95.7 PMD to MDI optical specifications for 100GBASE-SR4

95.8.5 Transmitter vertical eye closure (TxVEC)

Figure 95–3—TxVEC conformance test block diagram

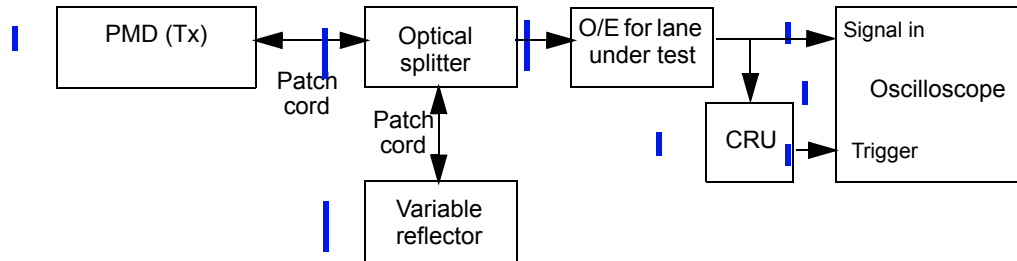
95.8.5.1 TxVEC conformance test set-up

A block diagram for the TxVEC conformance test is shown in Figure 95–3. Other measurement

Each optical lane is tested individually with all other lanes in operation. The optical splitter and variable reflector are adjusted so that each transmitter is tested with an optical return loss of 12 dB.

The combination of the O/E and the oscilloscope used to measure the optical waveform has a fourth-order Bessel-Thomson filter response with a bandwidth of 12.6 GHz. Compensation may be made for any deviation from an ideal fourth-order Bessel-Thomson response.

The clock recovery unit (CRU) has a corner frequency of 10 MHz and a slope of 20 dB/decade.

Figure 95-4—Illustration of the TxVEC measurement

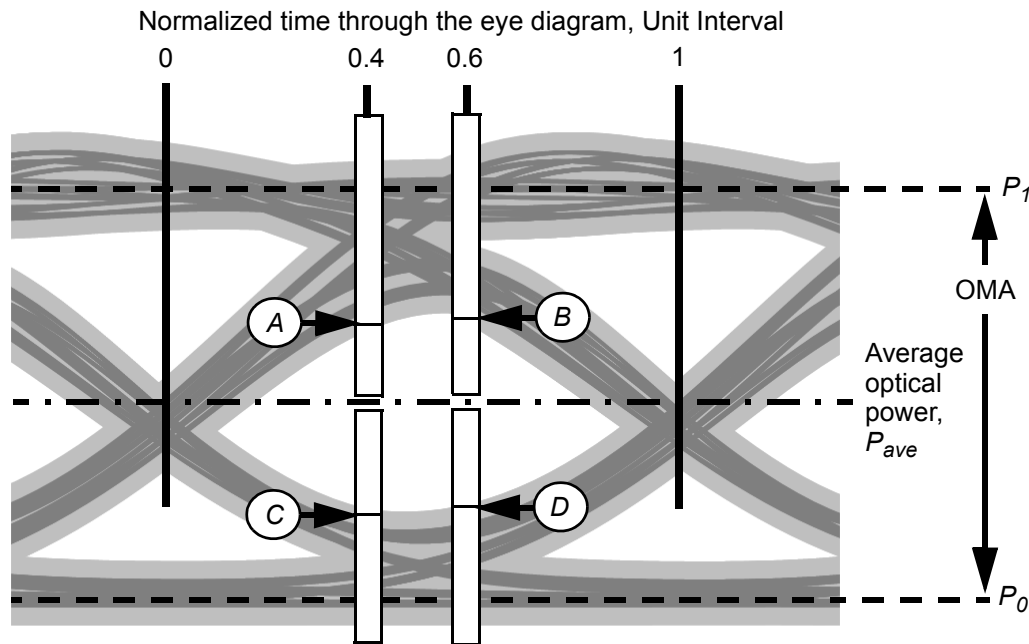
95.8.5.2 TxVEC measurement method

The 0 UI and 1 UI crossing points are determined by the time average of the eye diagram crossing points, as measured at P_{ave} , as illustrated in Figure 95–4.

Four vertical histograms are measured through the eye diagram, centered at 0.4 UI and 0.6 UI, and above and below P_{ave} , as illustrated in Figure 95–4.

Each histogram window has a width of 0.04 UI. Each histogram window has an inner height boundary which is set close to P_{ave} (so that no further samples would be captured by moving it closer to P_{ave}), and an outer height boundary which is set beyond the outer-most samples of the eye diagram, so that no further samples would be captured by increasing the outer boundary of the histogram. Starting from the boundaries closest to P_{ave} , the power at which the cumulative distribution of each histogram equals the 0.005th percentile of the total number of samples in the histogram is determined (these are the powers A , B , C , and

TxVEC is defined as the largest of the four quantities given by Equation (95-1) to Equation (95-4):
